**Re: APS Family School East Side**  
**3303 Monroe Street NE**  
**Traffic Circulation Layout**  
Engineer's Stamp dated 01-30-17 (G17-D019A)

Re: **APS Family School East Side**  
**3303 Monroe Street NE**  
**Traffic Circulation Layout**  
Engineer's Stamp 12-12-16 (G17-D019A)

**Re: APS Family School East Side**  
**3303 Monroe NE**  
**Traffic Circulation Layout**  
Engineer's/Architect's Stamp **6-10-16** (G17-D019A)

**C-10L**

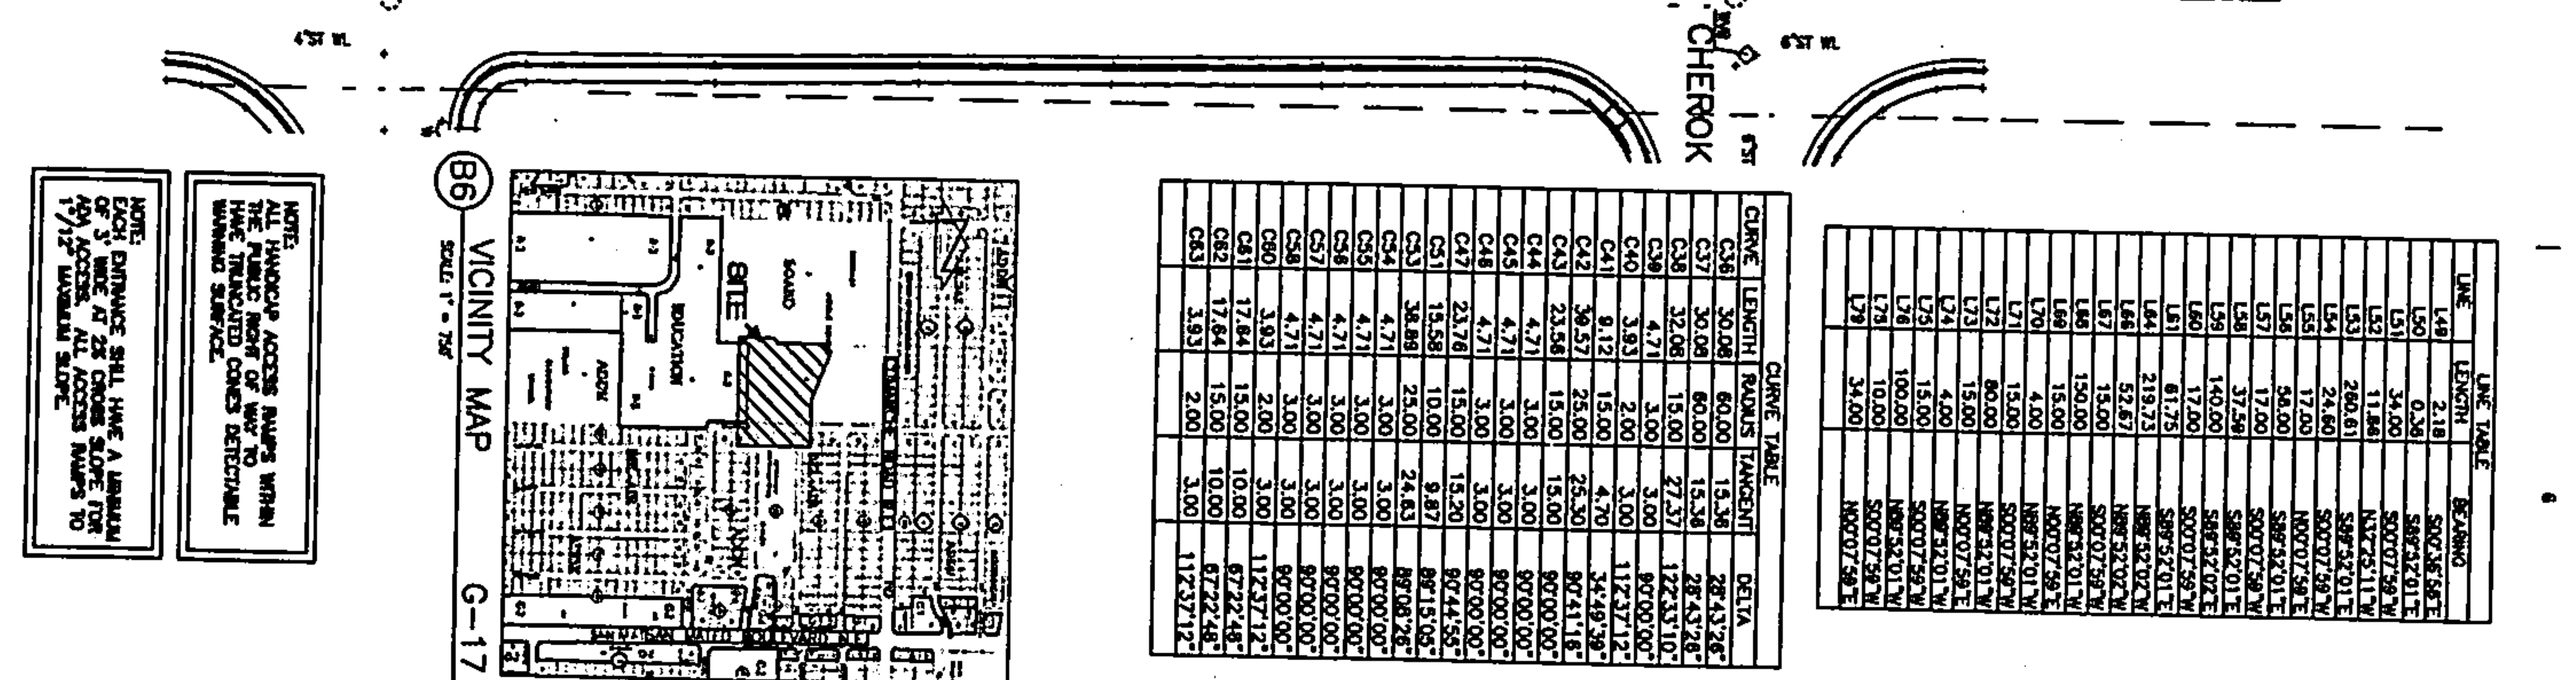
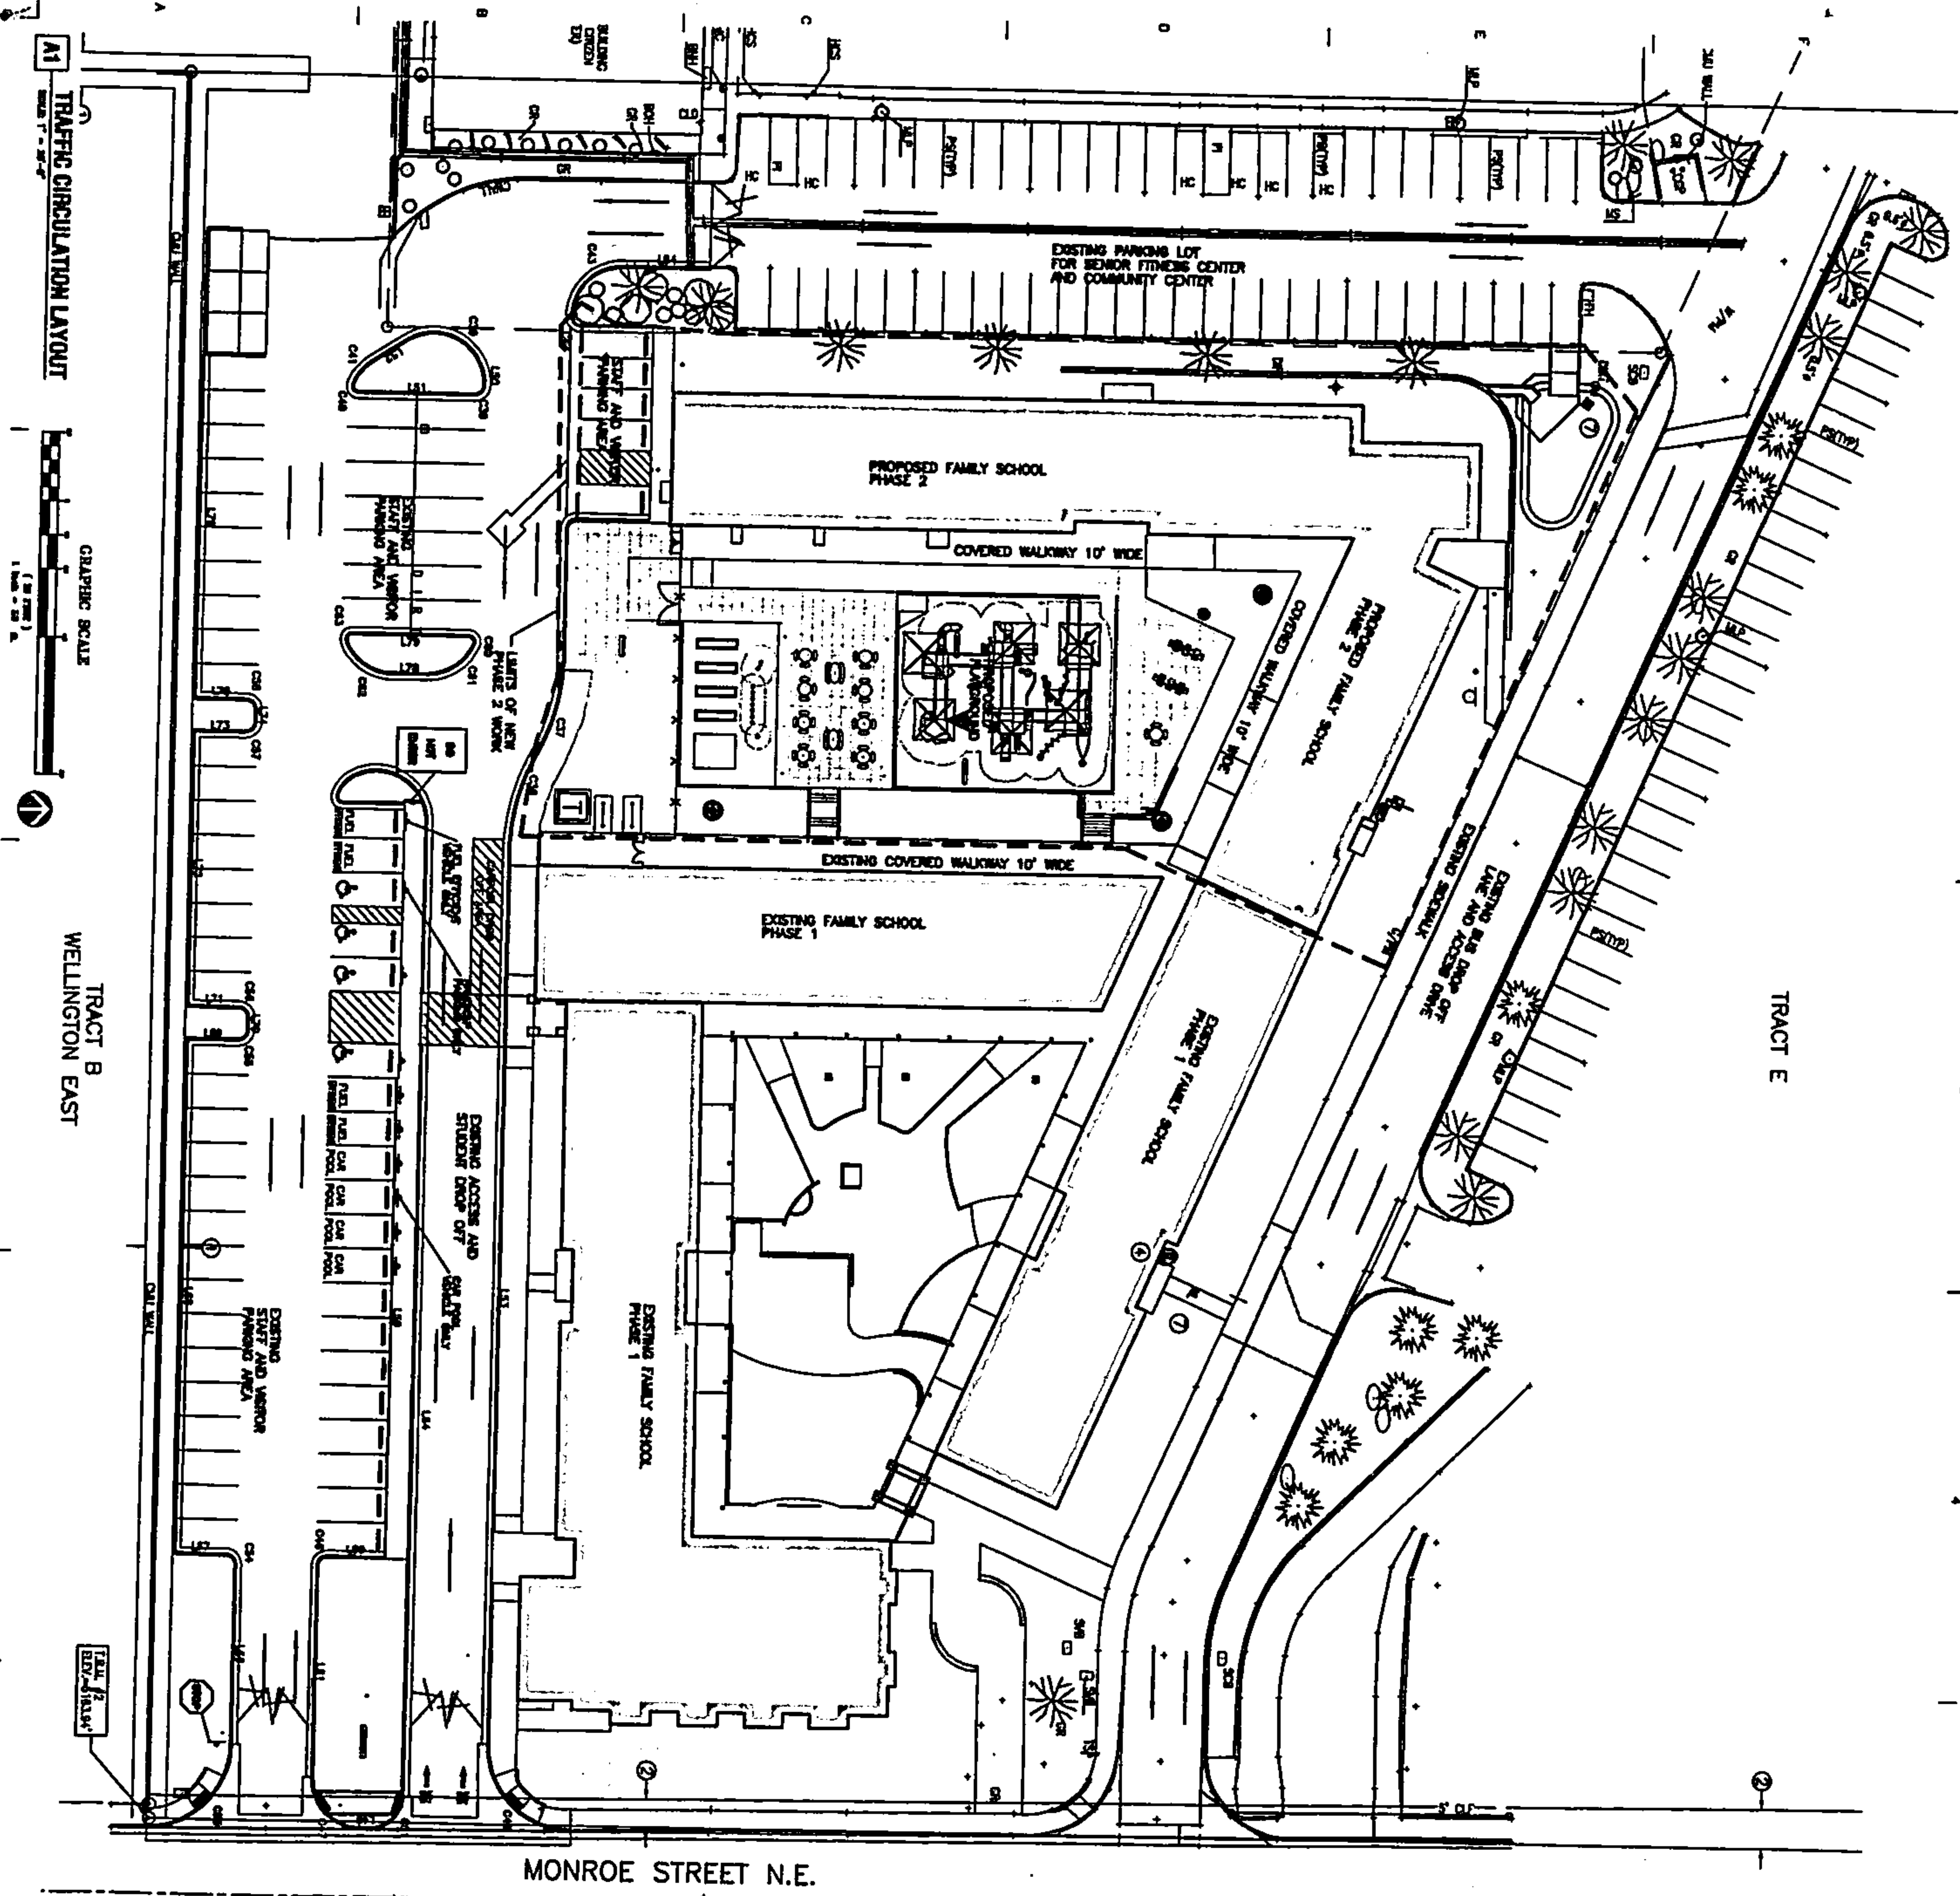
Based upon the information provided in your submittal received 12-12-16, the above referenced plan cannot be approved for Building Permit until the following comments are addressed:

1. Please review and revise plan to provide all information listed on the attached Traffic Circulation Layout checklist.
- ✓2. List the number of parking spaces required by the zoning code as well as the proposed number of parking spaces including bicycle and motorcycle parking.

- ✓3. Clarify the extents of the current phase. Provide a phasing plan.
4. The traffic circulation layout must be stamped, signed, and dated by an engineer or architect licensed in the state of New Mexico.

- ✓5. Identify all existing access easements and rights of way width dimensions.
- ✓6. Identify the right of way width, medians, curb cuts, and street widths on Monroe St.

- ✓7. Please list the width and length for all existing and proposed parking spaces. Some dimensions are not shown.
- ✓8. Please dimension the proposed sidewalk widths.

- ✓9. Show all drive aisle widths that effect current phasing. Some dimensions are not shown.
10. Label the compact parking spaces by placing the words "COMPACT" on the pavement of each space. *NO COMPACT USED.*

11. The handicap accessible spaces must include an access aisle. Van accessible aisles should be 8ft wide; all others should be 5ft wide. *existing only NO MORE TO ADA spaces*

12. The ADA accessible parking sign must have the required language per 66-7-352.4C NMSA 1978 "Violators Are Subject to a Fine and/or Towing." Please call out detail and location of HC signs. *(signs not modified)*

13. The ADA access aisles shall have the words **"NO PARKING"** in capital letters, each of which shall be at least one foot high and at least two inches wide, placed at the rear of the parking space so as to be close to where an adjacent vehicle's rear tire would be placed. (66-1-4.1.B NMSA 1978) *NOT MODIFIED*

14. The ADA parking space has a clearly visible, blue, International Symbol of Accessibility painted on the pavement at rear of the space (66-1-4.1.E NMSA 1978) or MUTCD recommends a white symbol on a blue background. *NOT MODIFIED*

15. Show all drive aisle widths and radii. Some dimensions are not shown. *EXISTING CONDITIONS*
16. List radii for all curves shown; for passenger vehicles, the minimum end island radius for passenger vehicles is 15 ft. Radius for delivery trucks, fire trucks, etc. is 25 ft. or larger. *SEE WORK VINE PARK FROM PLANS*

- ✓ 17. Provide a min 6" or max 8" high concrete barrier curb or other acceptable barrier between landscaping and parking areas and/or drive aisles. Please call out detail and location of barrier curb.

- ✓ 18. Per the zoning code, a 6 ft. wide ADA accessible pedestrian pathway is required from the public sidewalk to the building entrances. Please clearly show this pathway and provide details.

19. Please specify the City Standard Drawing Number when applicable. *NO APPLICATION*
20. Please include a copy of your shared access agreement with the adjacent property owner.
